C32 PREAMPLIFIER

SERVICE INFORMATION

STARTING WITH SERIAL NO. AY1001

HEADPHONE MONITOR PC BOARD

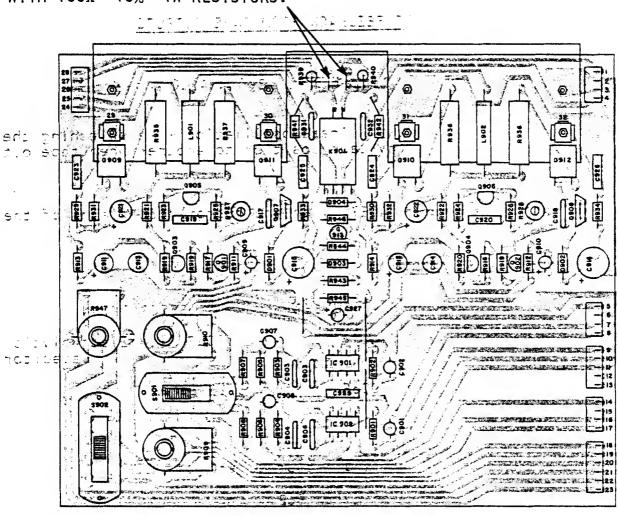
CORRECT POSSIBLE SHORTING CONDITION

MODEL: C 32 Preamplifier Serial No.: Below AY1295

PURPOSE OF MODIFICATION: To correct the condition where by the preamplifier's headphone amplifier channels are shorted together when plugging headphones into the top headphone jack.

REMOVE JUMPERS AND REPLACE WITH 100Ω 10% 1W RESISTORS.

- Remove top cover.
- 2. Make a sketch of the connectors connections to the headphone monitor PC boards.
- Remove the connectors from headphone monitor PC board 3. and remove headphone monitor PC board from the chassis.
- Replace jump wire that jumps K901 to connector pin 28 with a $136453\ 100\Omega\ 10\%$ lW resistor.
- 5. Replace jump wire that jumps K901 to connector pin 24 with a $136453 100\Omega$ 10% lW resistor.
- Reinstall the headphone monitor PC board and replace top cover.
